## **AGENDA**

### La Vergne Planning Commission August 27, 2024 at 6:00 PM

## **MINUTES OF THE REGULAR MEETING OF THE CITY OF LA VERGNE PLANNING COMMISSION HELD ON JULY 30, 2024 AT LA VERGNE CITY HALL, LA VERGNE, TENNESSEE.**

**MINUTES OF THE WORKSHOP OF THE CITY OF LA VERGNE PLANNING COMMISSION HELD ON AUGUST 13, 2024, AT LA VERGNE CITY HALL, LA VERGNE, TENNESSEE.**

PROJ. # 18038 DATE: 9-27-2021 REV: 10-14-2021 FILE: CC-PHASE 2 DRAWN BY: ATS SCALE: 1" = 50' SHEET 2 OF 2

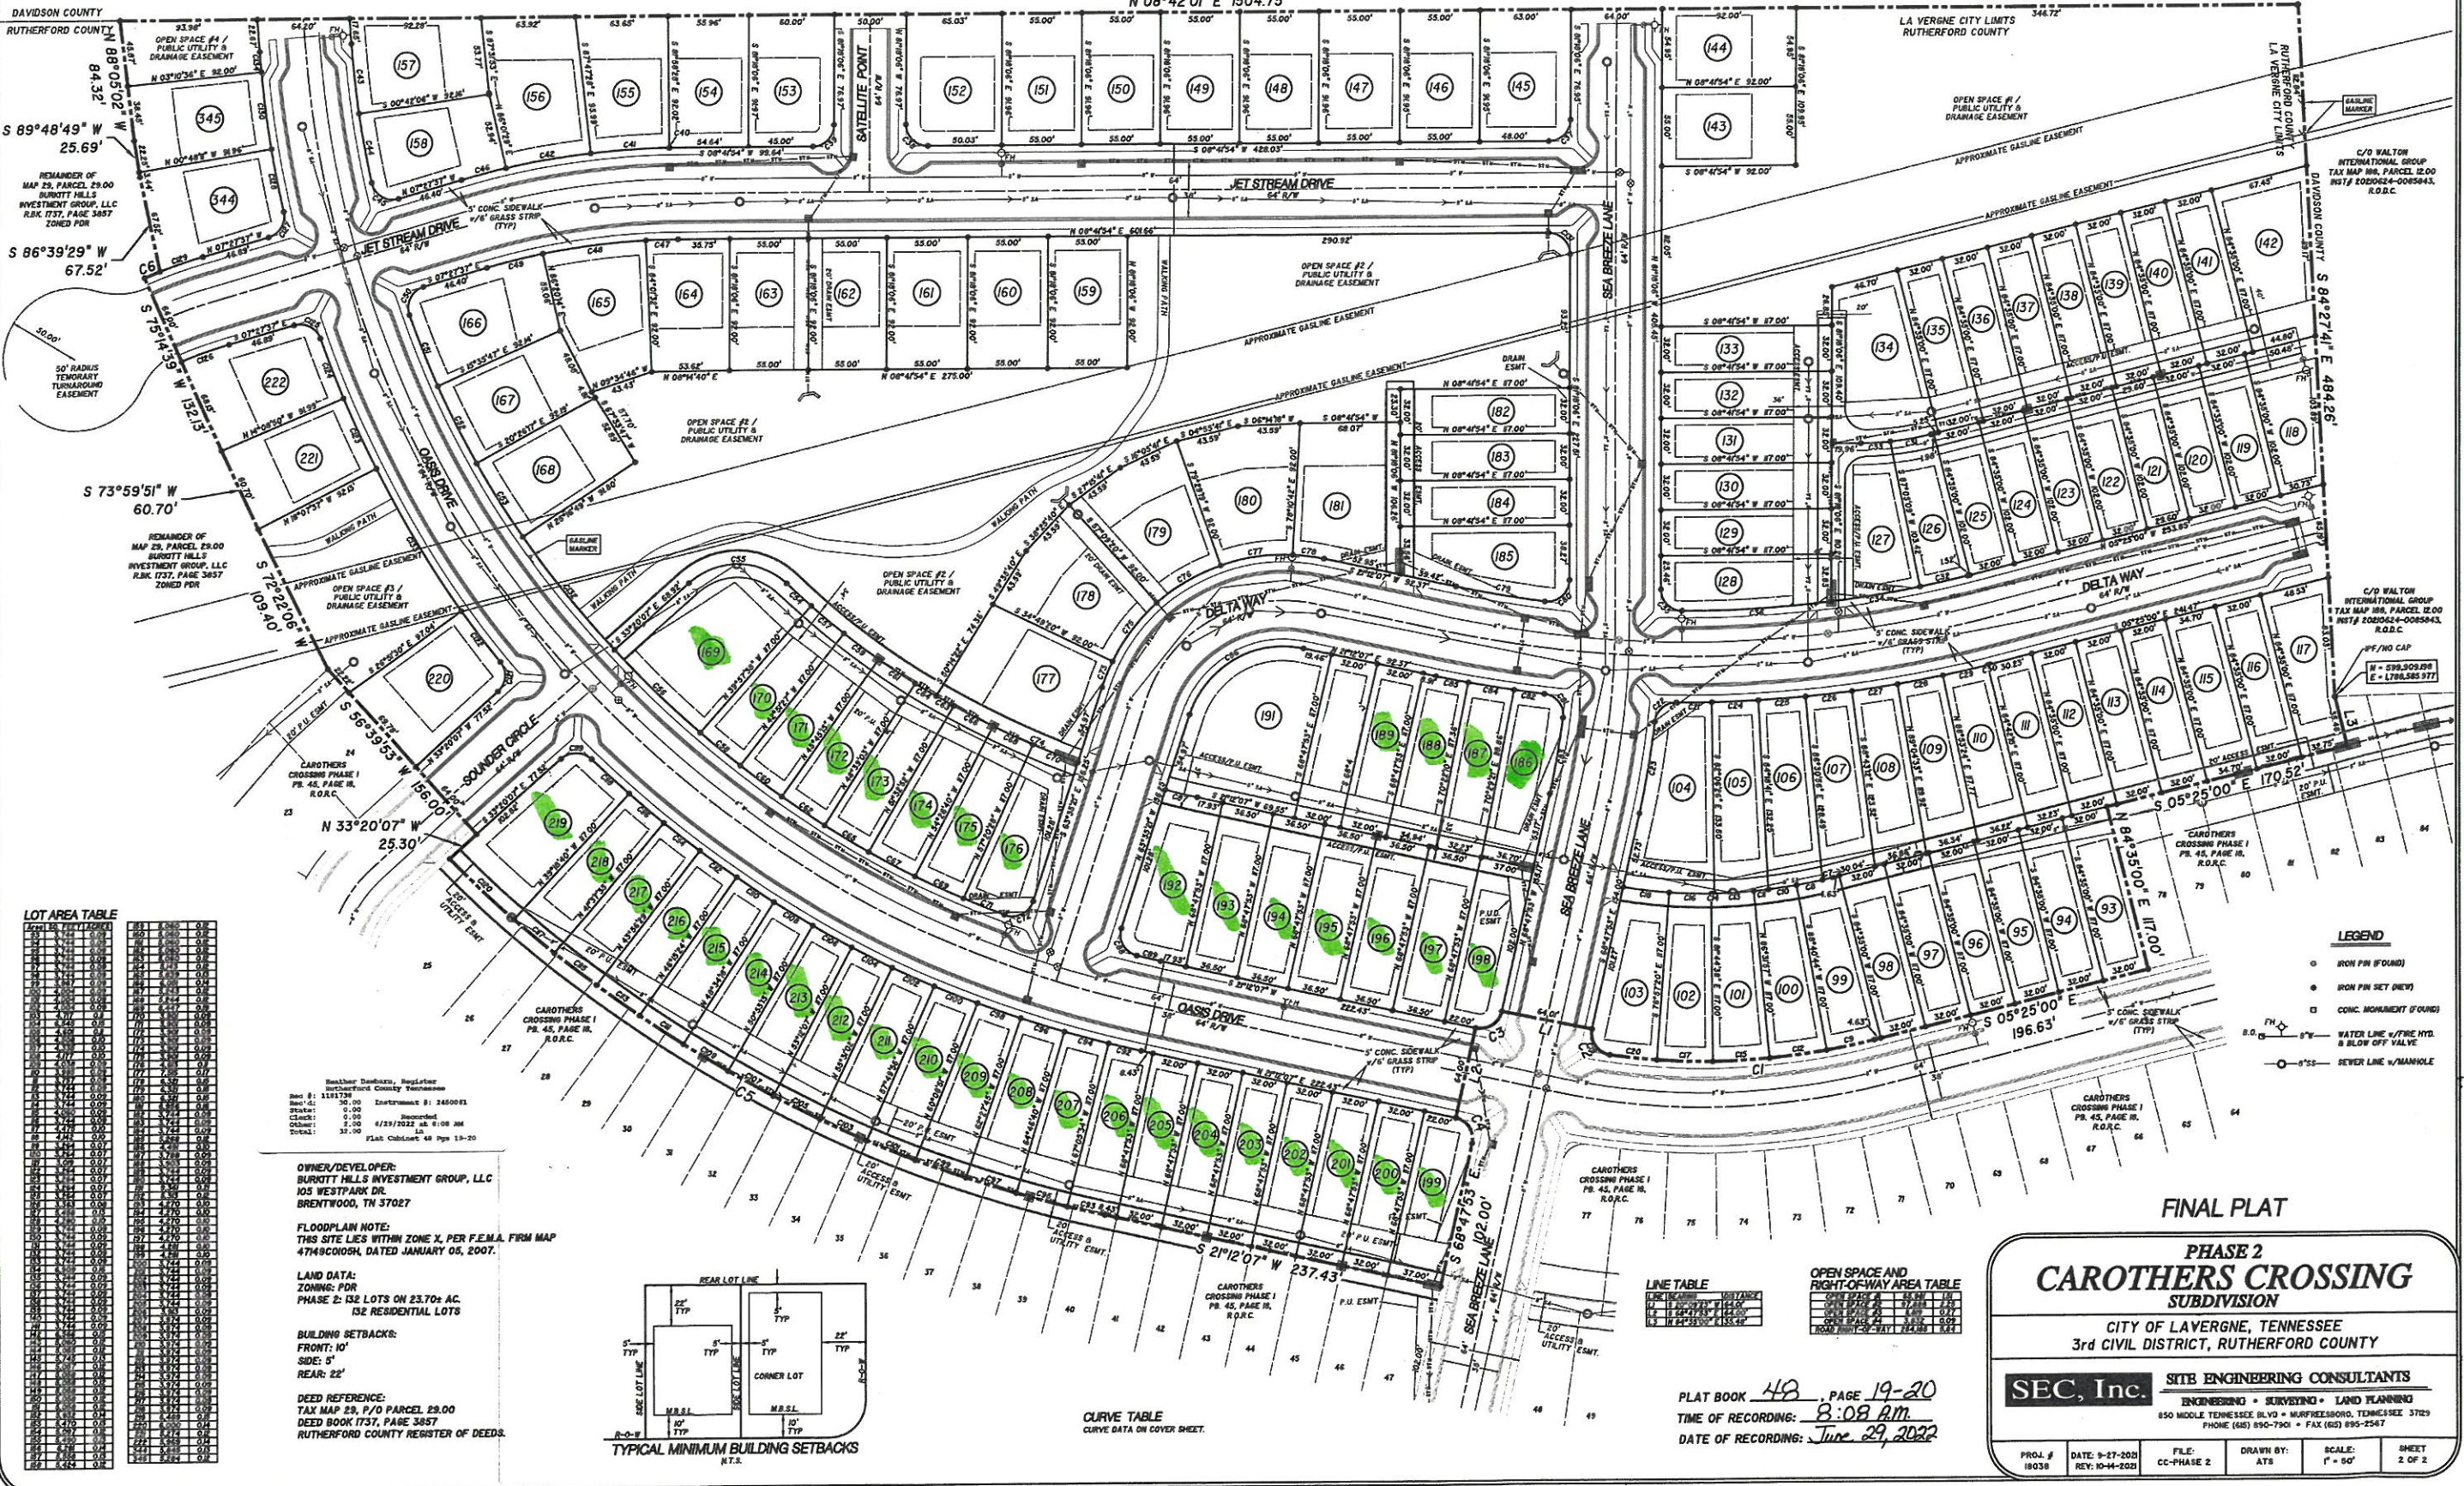
- Place 4" wide single solid white line (SSWL) striping separating streetside parking from driving lanes along all public roads as shown on plans.
- On Delta Way in front of address 336 there are two sections of concrete in the gutter line that needs to be chipped out

- Valve at rear of 300 Delta way is covered by a car, cannot access. No answer at residents to move car.
- FH in rear of 300 Delta way needs raised, currently at 14". Needs to be at 18" min.

- All curb and area inlet structures, headwall and pipe junctions need to be grouted with Portland cement.
- The area in front of all headwalls needs to drain as shown on the plans. If any area around the headwall have washed out or have silt build up that area needs to be reworked and stabilized with seed and matting.
- Remove all not needed erosion control.
- Be sure all inlet boxes are clean and drain properly.
- Check to be sure all pipes are clean and drain properly.
- Be sure all roads are clean.
- Be sure all drainage area drains as shown on the plans. if any area needs reworked that that area needs stabilized with seed and matting.
- All bare areas need stabilized with seed and straw or matting.

- The major issues @ Carothers Crossing Phase II have been corrected.
- The only thing the city is waiting for is the CCTV footage that the developer needs to provide. I spoke to the developer a few weeks ago, and he was still waiting on the footage from the company.
